REVIEW OF CORROSION ASPECTS OF HIGH-LEVEL WASTE STORAGE TANKS AT WEST VALLEY

**Nuclear Regulatory Commission
Contract NRC-02-88-005**

**Center for Nuclear Waste Regulatory Analyses
San Antonio, Texas**

April 1993

Figure 2-4. Section of Tank 8D-1 (Prowse and Schiffhauer, 1991)

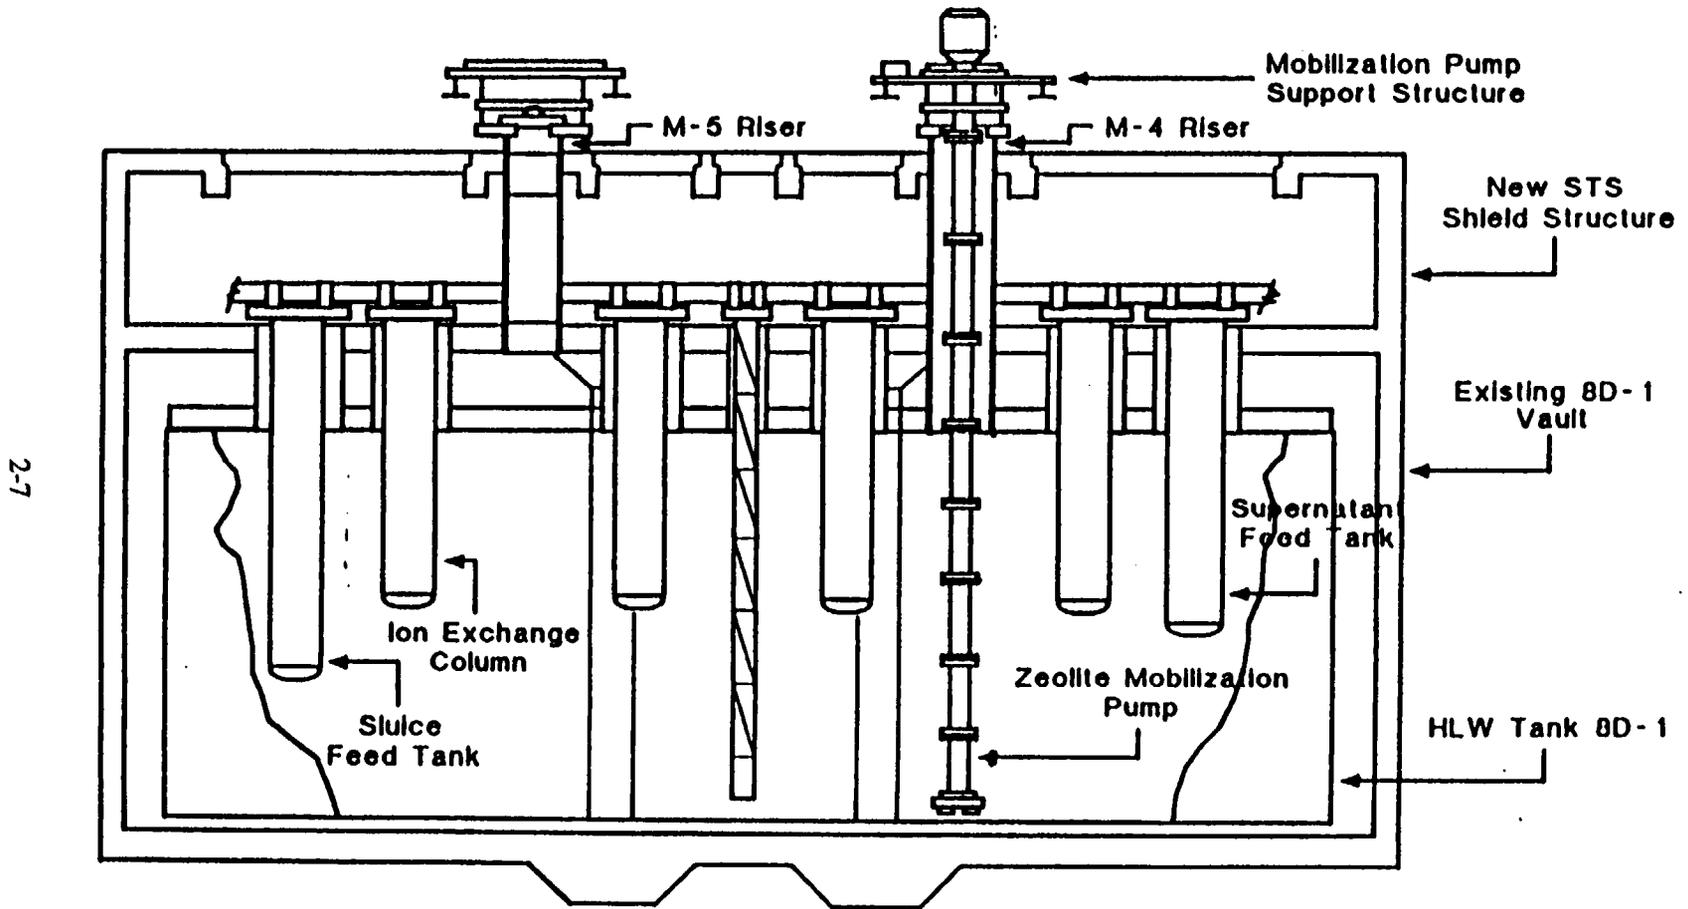
Regarding the activities reported to-date, it is important to note that a potential risk for pitting or crevice corrosion underneath the zeolite layer in Tank 8D-1 still exists despite the addition of nitrite. It appears that the occurrence of pitting corrosion in the laboratory tests conducted at Savannah River (Congdon, 1988; Zapp and Hobbs, 1992), as related to the depletion of hydroxide ions at the waterline, is not necessarily the same process that occurred on the specimens covered by zeolite in Tank 8D-1. Therefore, it would be desirable to initiate the monitoring in the zeolite region soon. In addition to the monitoring using electrical resistance or linear polarization methods, it will be valuable to have specimens attached to the probe in a similar manner to those currently located in Tank 8D-2 for periodic examination.

Figure 3-1. Effect of NaNO₂ and NaOH on SCC of A 285-B steel in 5 M NaNO₃ solution at 97°C. (Ondrejcin, 1979)

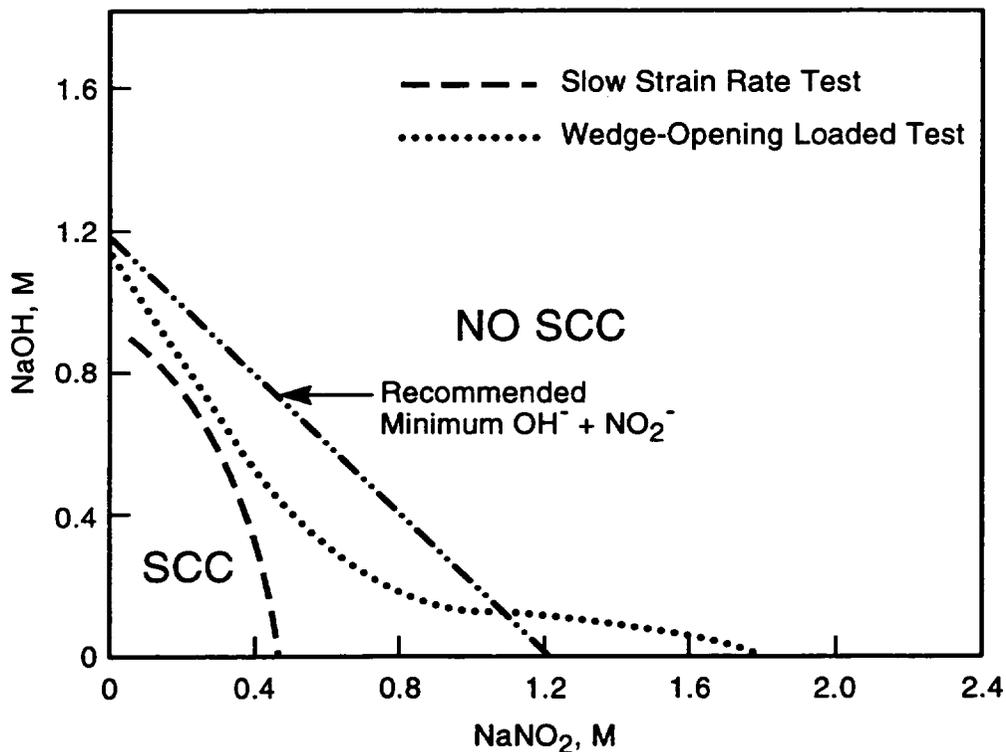
The previous discussion on SCC studies suggests that in the West Valley tanks the occurrence of SCC may be prevented by the presence of relatively high concentrations of nitrite and hydroxide with respect to that of nitrate, as shown by Table 2-2. The combined concentrations of OH^- and NO_2^- anions define a point located in the noncracking region of Figure 3-1. In addition, the concentration of NO_3^- in the 8D-2 tank is 1 M rather than 5 M as in the data shown in Figure 3-1 and the temperature is lower than 97°C . Therefore, it can be expected that the initiation and growth of stress corrosion cracks is inhibited. This consideration of environmental factors seems to be a valid approach for evaluating the potential risk of environmentally assisted cracking in the case of West Valley tanks. However, changes in the chemical composition of the waste or variations in temperature and corrosion potential may lead to the occurrence of cracking, which makes a monitoring and inspection program fully justifiable.
